RIVER BEND STATION ENVIRONMENTAL REPORT

OPERATING
LICENSE
STAGE

SUPPLEMENT 6

SUPPLEMENT 6 INSERTION INSTRUCTIONS RIVER BEND STATION
ENVIRONMENTAL REPORT - OPERATING LICENSE STAGE

FIGURE 3.1-2a

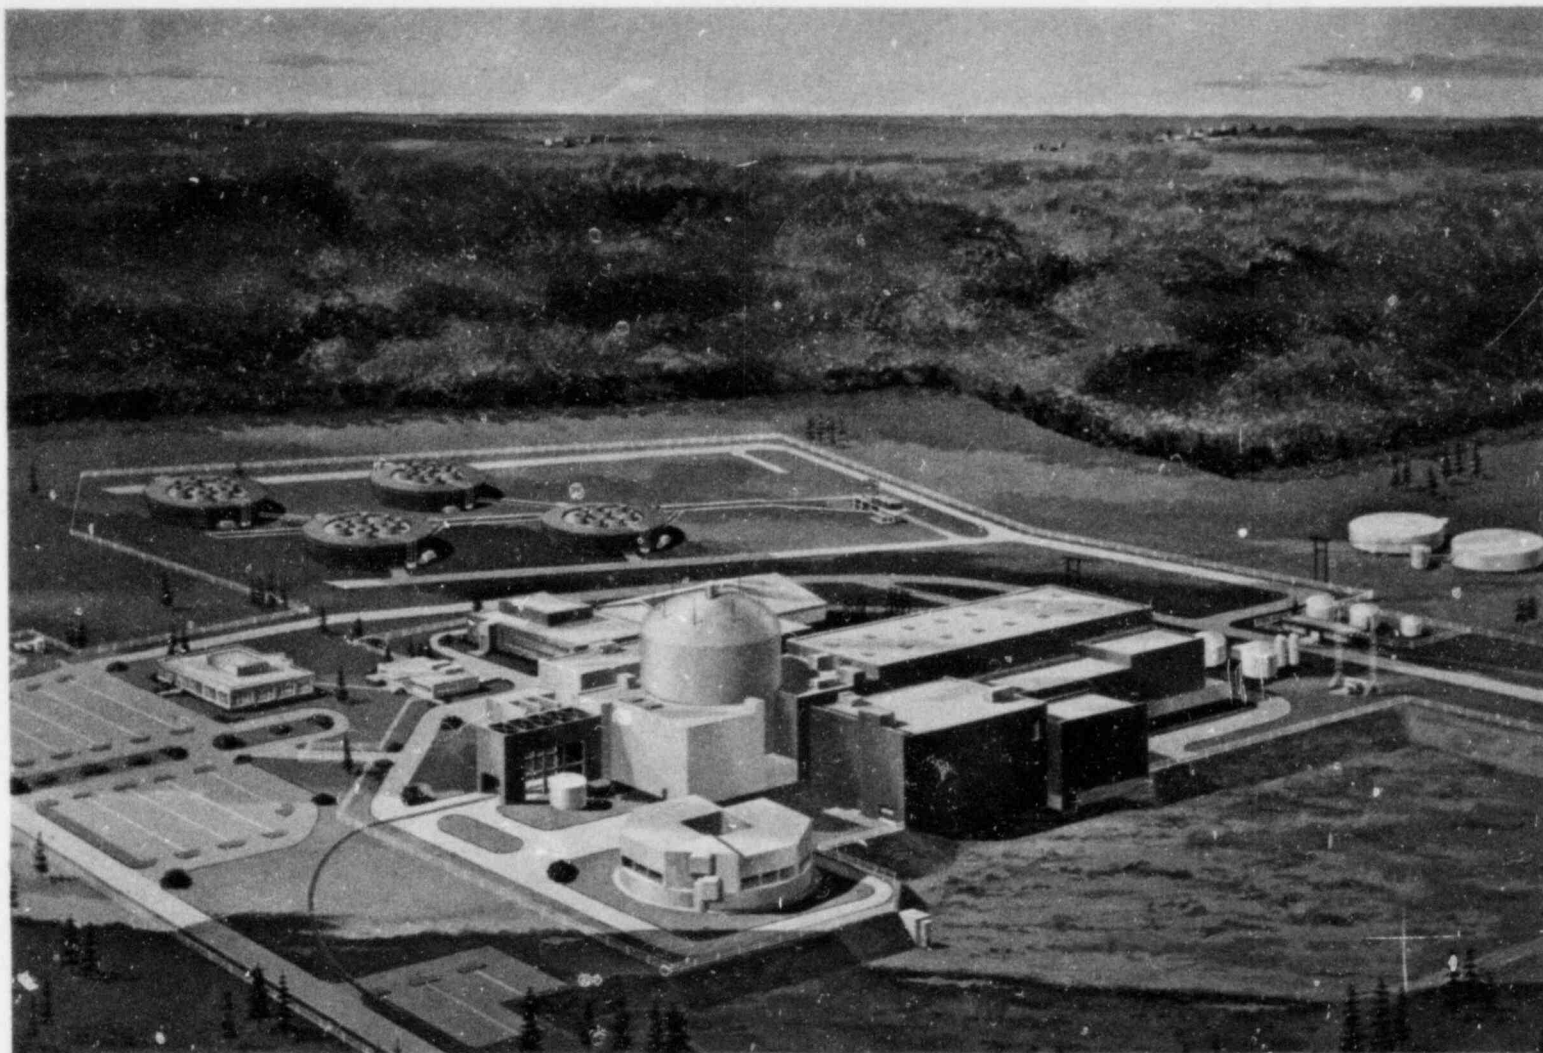
The external appearance of the plant and plant layout are discussed in Section 3 of the CP-FES and depicted in Figure 2.1-3 in terms of two units. In light of the current status of Unit 2 which is not scheduled, provide a discussion, accompanied by a new site layout figure, which incorporates Unit 1 physical structure and features and reflects any additions (i.e., Emergency Operations Facility), relocations, reorientations or other changes which have occurred since publications of the CP-FES.

6 | An artist's sketch of a one-unit plant is shown in Figure 3.1-2a.
